Re: NH SEC Docket No. 2015-04: Public Service Company of New Hampshire d/b/a Eversource Energy (“PSNH” or the “Applicant”) for a New 115 kV Transmission Line from Madbury Substation to Portsmouth Substation.

NH PUC Docket DE 16-441, DE 16-442: Revisions to PSNH’s Petitions for Licenses to Construct and Maintain Electric Lines, Neutral Wire and Fiber Optic Cable Over and Across Public Waters and Public Lands of New Hampshire

Revisions to the
NHPUC Public Water and Public Land Crossing
License Applications

SUMMARY
Revisions between Originally Submitted Petition
And Revised Engineering Design

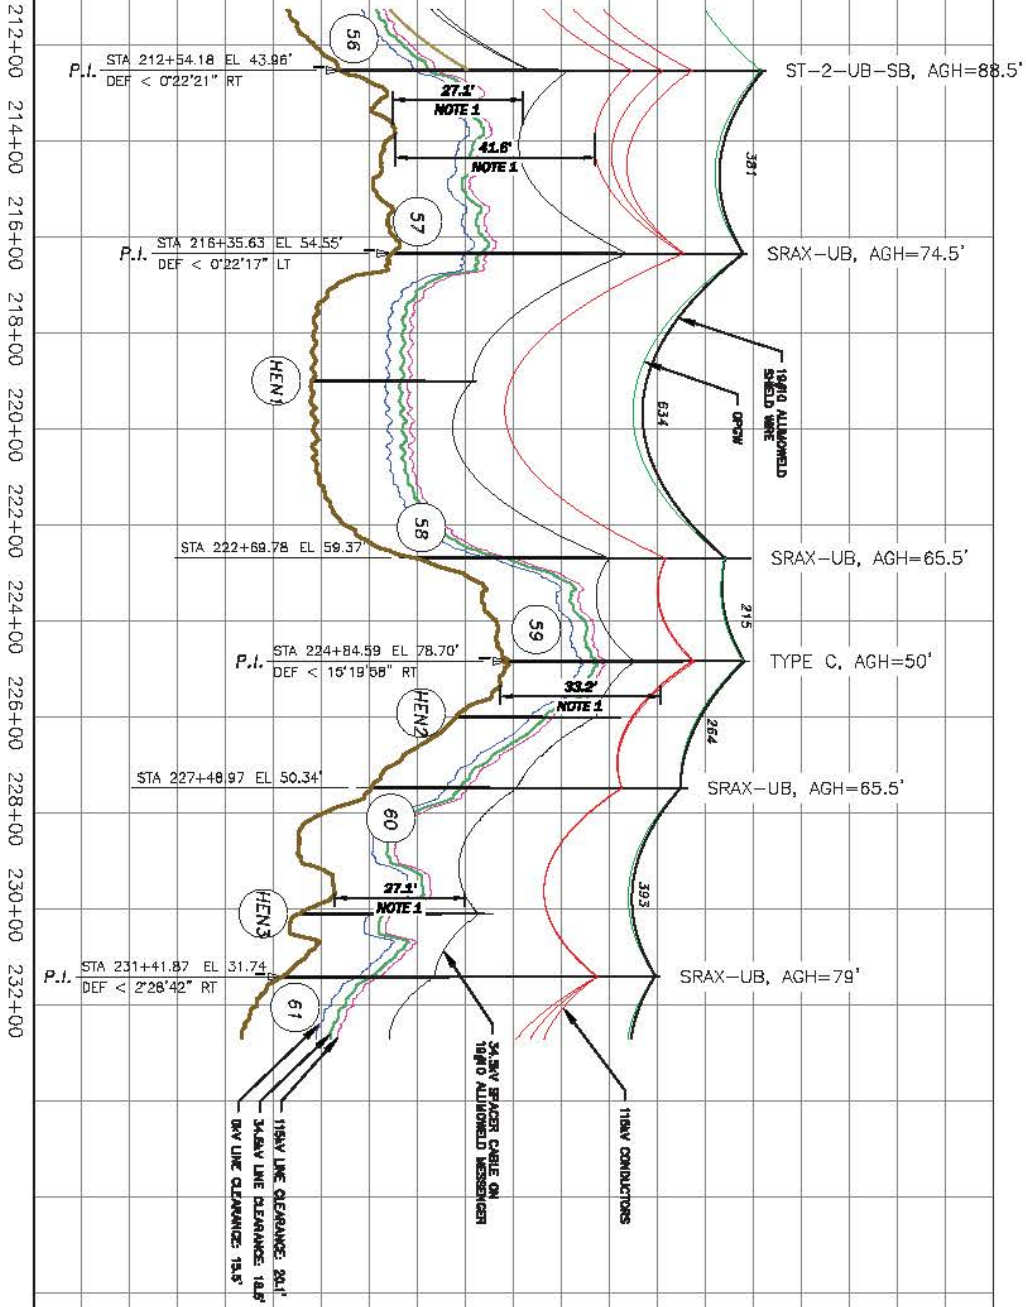
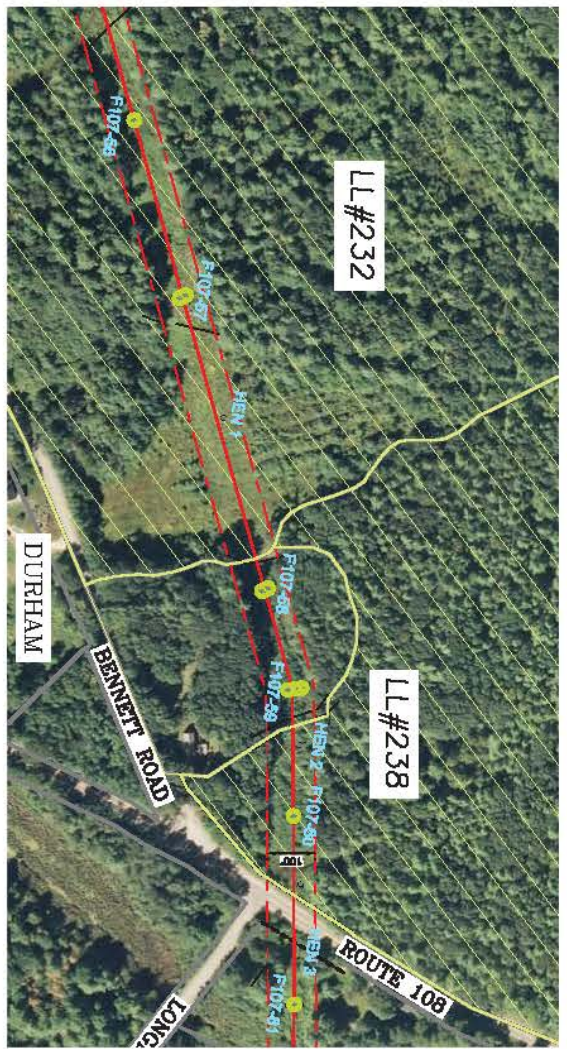
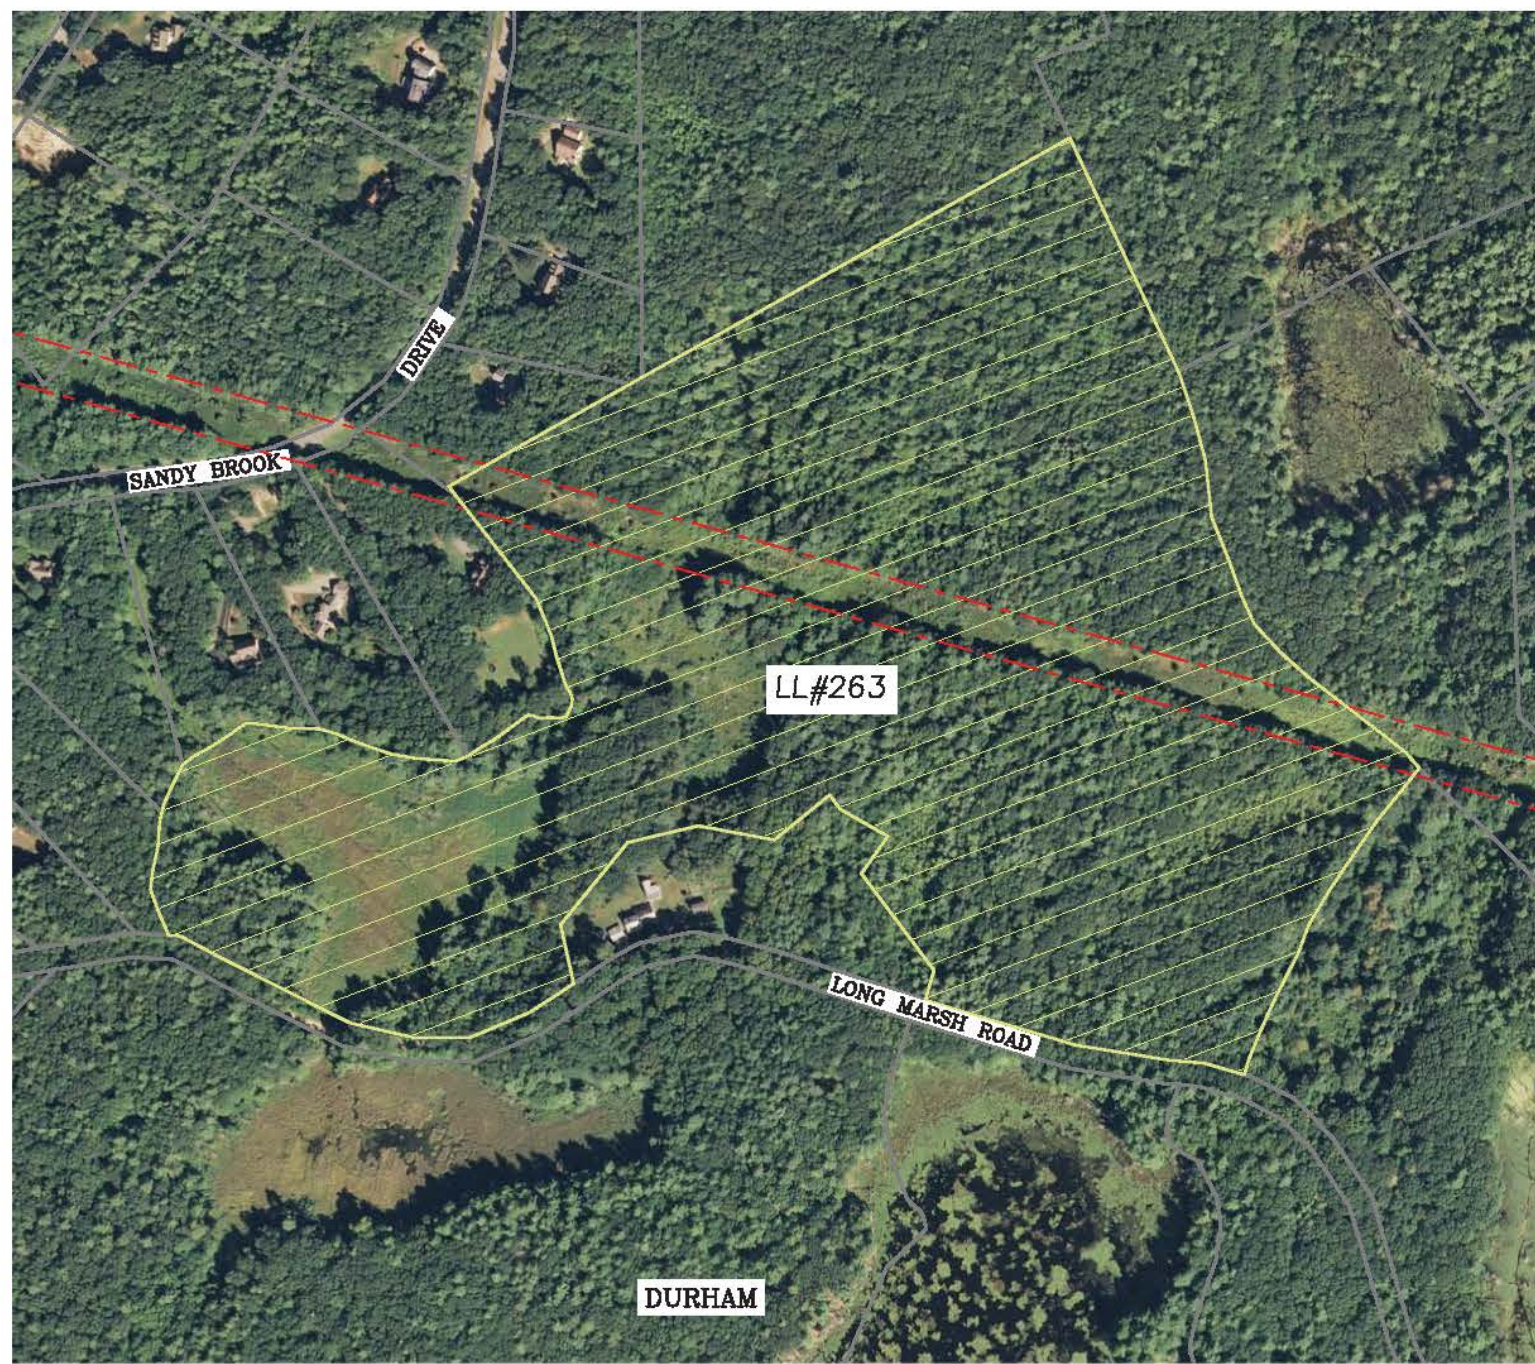
1. Paragraph #1- Revised Drawing number F10799002 (Exhibit 3) has been supplied. No changes to location plan (Exhibit 1).
2. Paragraph #3- **Change** “RAX-UB” to “SRAX-UB”.
3. Paragraph #3 - **Change** “nine inches” to “six inches”
4. Paragraph #3 - **Change** “15 feet” to “11.75 feet”
5. Table 1 Column 3- **Change** 15.5 feet to 18 feet
6. Paragraph #5- **Change** “water” to “land”
7. **Replace** Table 3 with revised table below

Structure (Back)	Height (Ft)	Structure (Ahead)	Height (ft)	Span (ft)	Clearance At 285°F (ft)
59	50	60	66	264	33.2
60	66	61	79	393	43.2

Structure (Back)	Height (Ft)	Structure (Ahead)	Height (ft)	Span (ft)	Clearance At 212°F (ft)
59	50	60	66	264	21.6
60	66	61	79	393	23.1

Structure (Back)	Height (Ft)	Structure (Ahead)	Height (ft)	Span (ft)	Clearance At 120°F (ft)
59	50	60	66	264	23.6
60	66	61	79	393	25.1

SEACOAST RELIABILITY PROJECT
 STRUCTURES #74-80
 STATE OF NH PROPERTY CROSSING
 SCALE: H: 1"=200', V: 1"=20'
 TOWN: DURHAM
 TRANSMISSION LINE: F107
 SHEET 1 OF 1
 F10799004

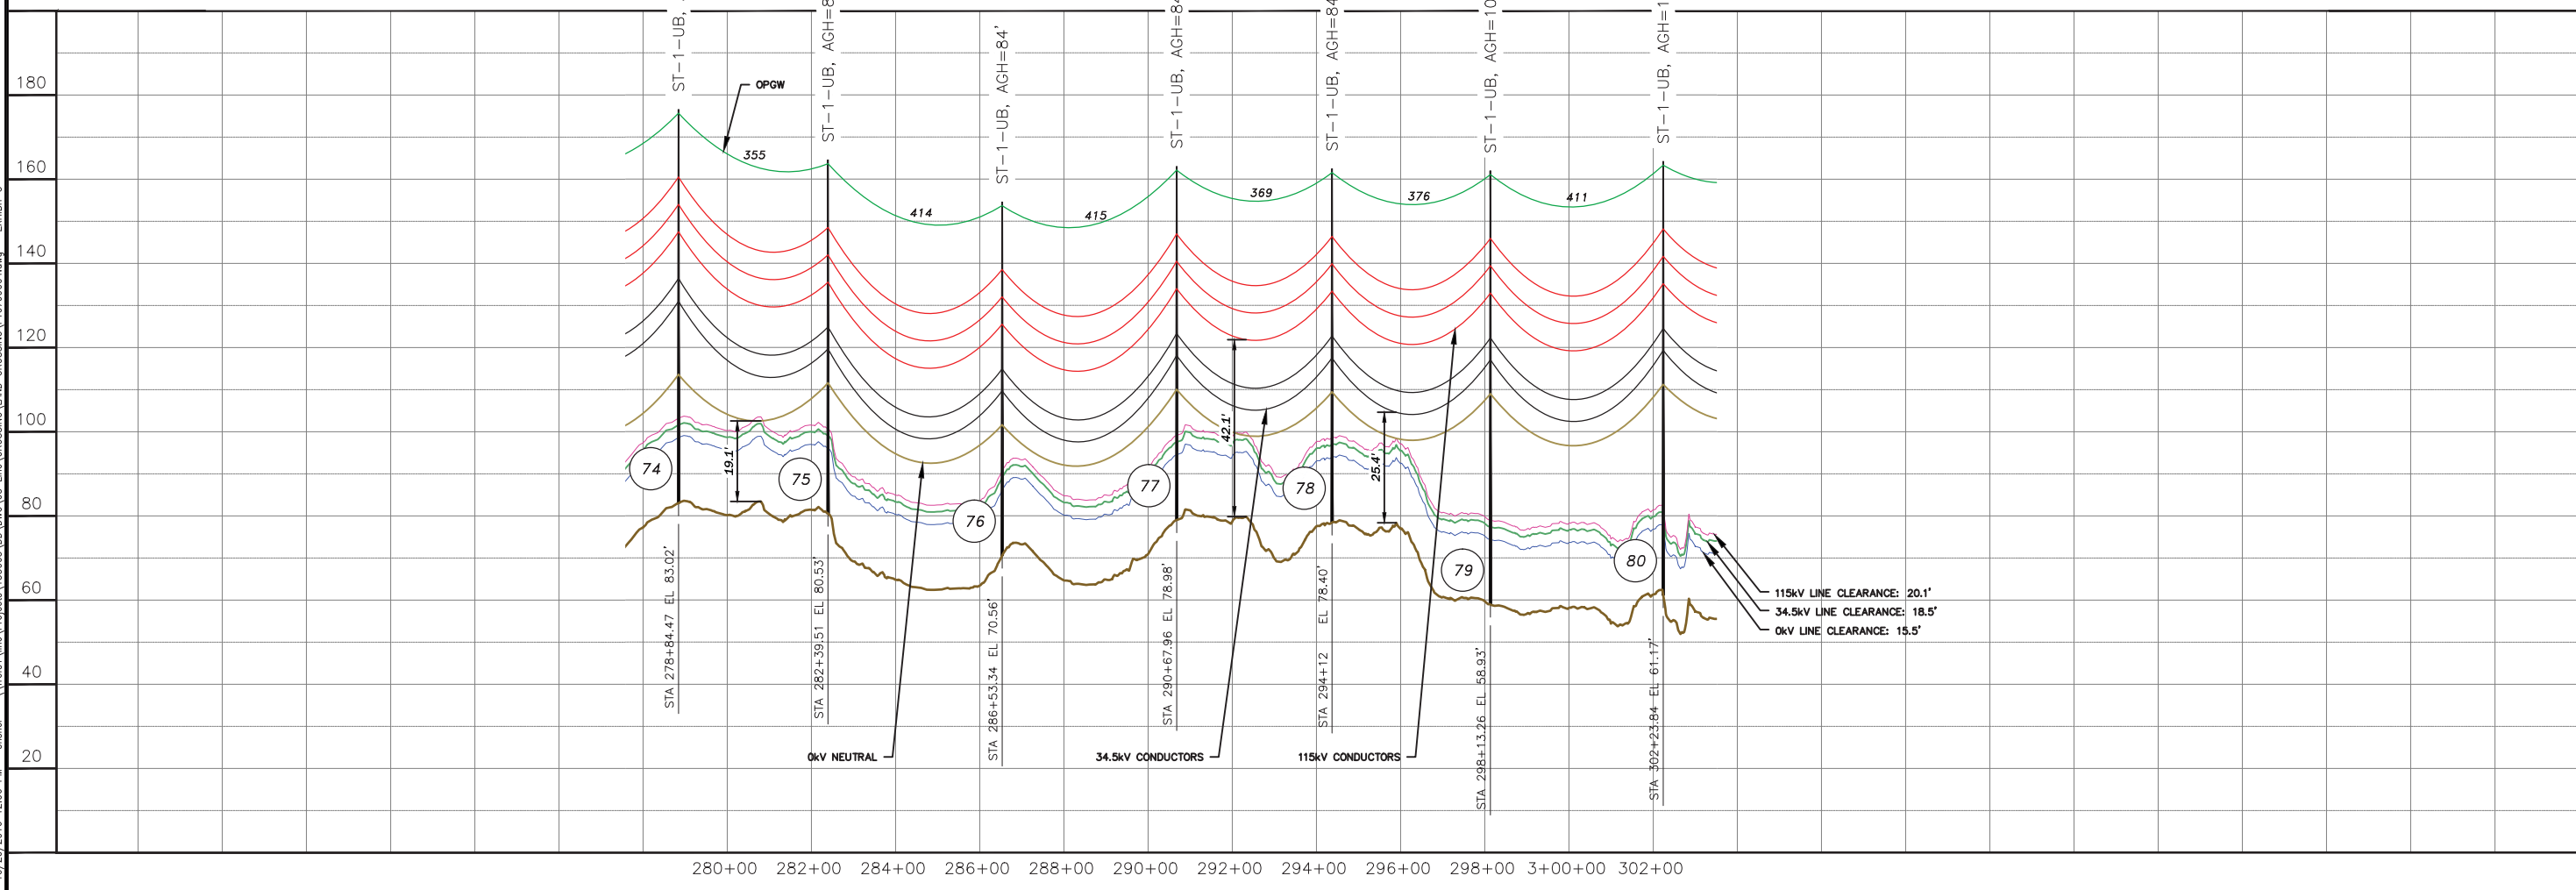
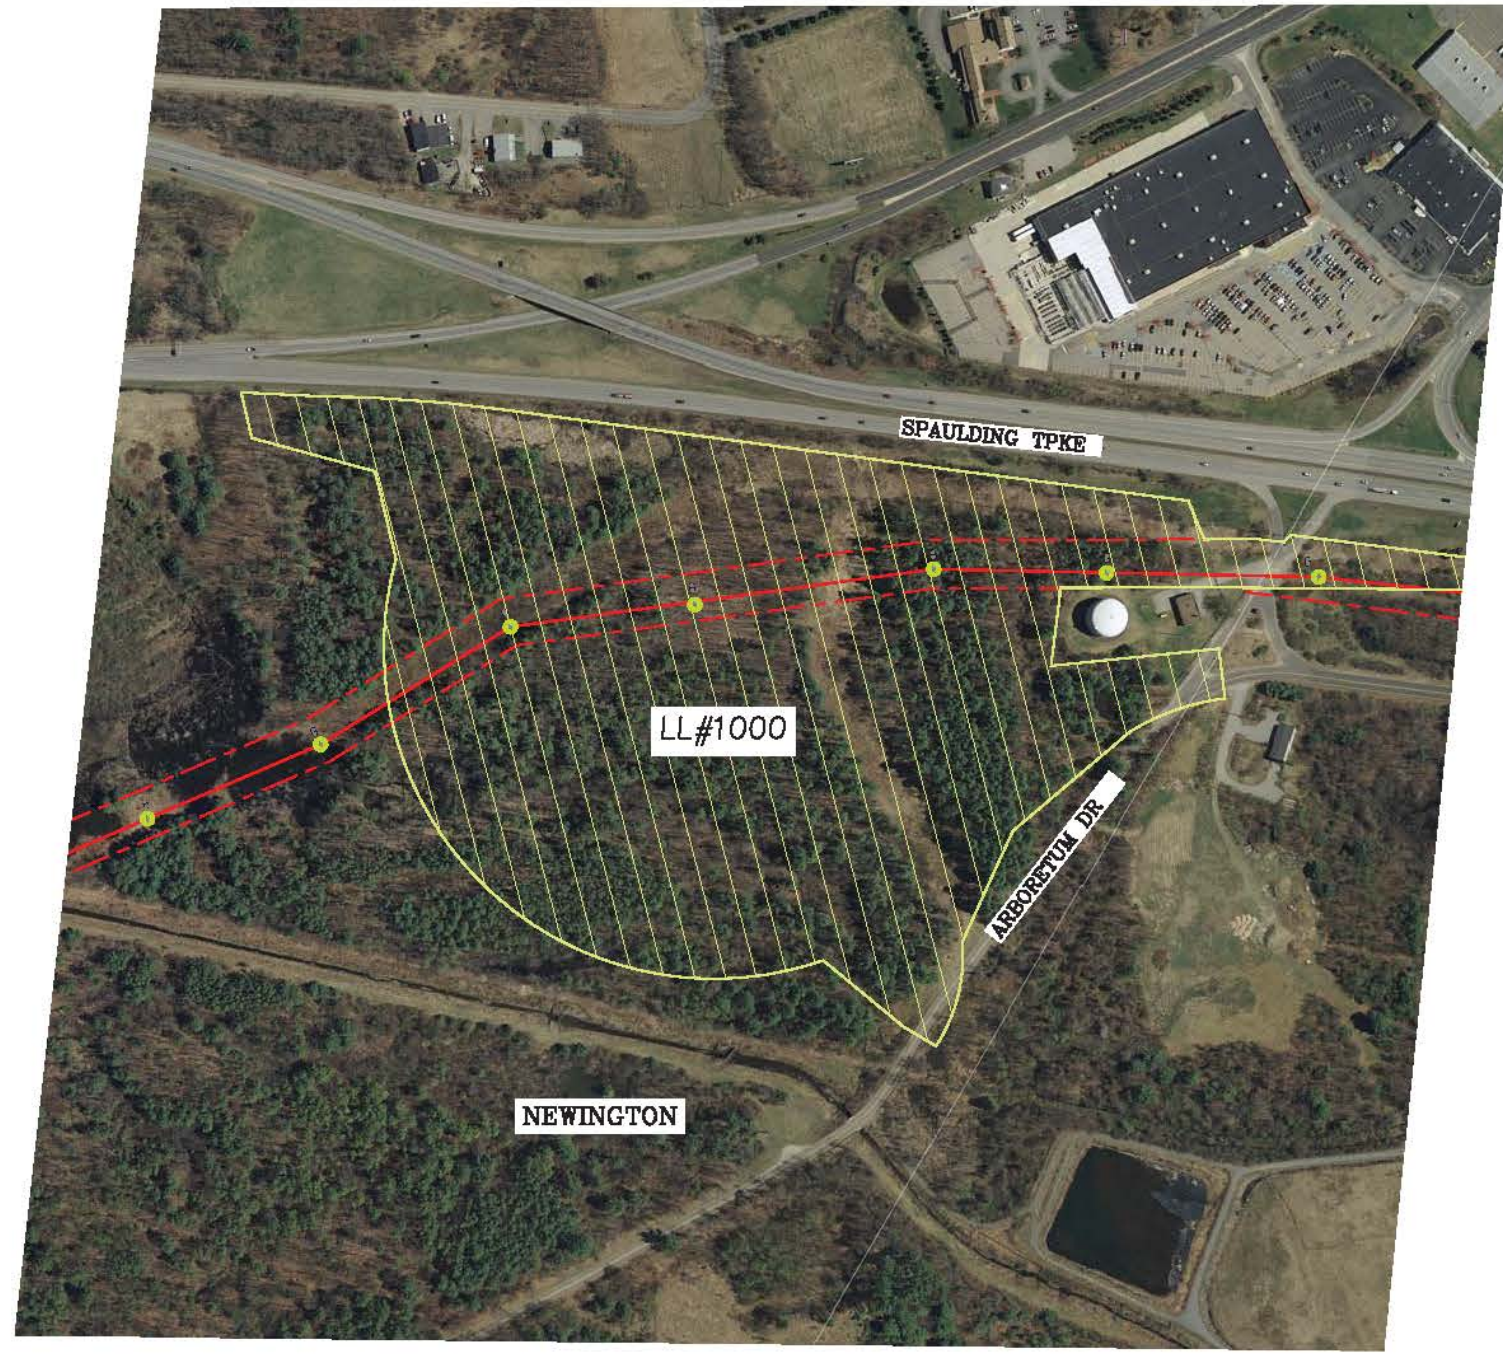
1. Paragraph #1- Revised Drawing number F10799004 (Exhibit 5) has been supplied. No changes to location plan (Exhibit 4).
2. Paragraph #3- **Change** “WT-1-UB to “ST-1-UB”.
3. Paragraph #3 - **Change** “7.5-15 feet” to “7.5-13 feet”
4. Paragraph #3 - **Change** “nine inches” to “six inches”
5. Paragraph #3 - **Change** “7.5 feet” to “7.0 feet”
6. Table 1 Column 3- **Change** 15.5 feet to 18 feet
7. Paragraph #5- **Change** “water” to “land”
8. **Replace** Table 3 with revised table below

Structure (Back)	Height (Ft)	Structure (Ahead)	Height (ft)	Span (ft)	Clearance At 285°F (ft)
74	93.5	75	84	355	47.4
75	84	76	84	414	53.1
76	84	77	84	415	47.4

77	84	78	84	369	42.1
78	84	79	103	376	44.9
79	103	80	103	411	61.5

Structure (Back)	Height (Ft)	Structure (Ahead)	Height (ft)	Span (ft)	Clearance At 212°F (ft)
74	93.5	75	84	355	30.1
75	84	76	84	414	35.1
76	84	77	84	415	30.1
77	84	78	84	369	25.5
78	84	79	103	376	25.4
79	103	80	103	411	44.0
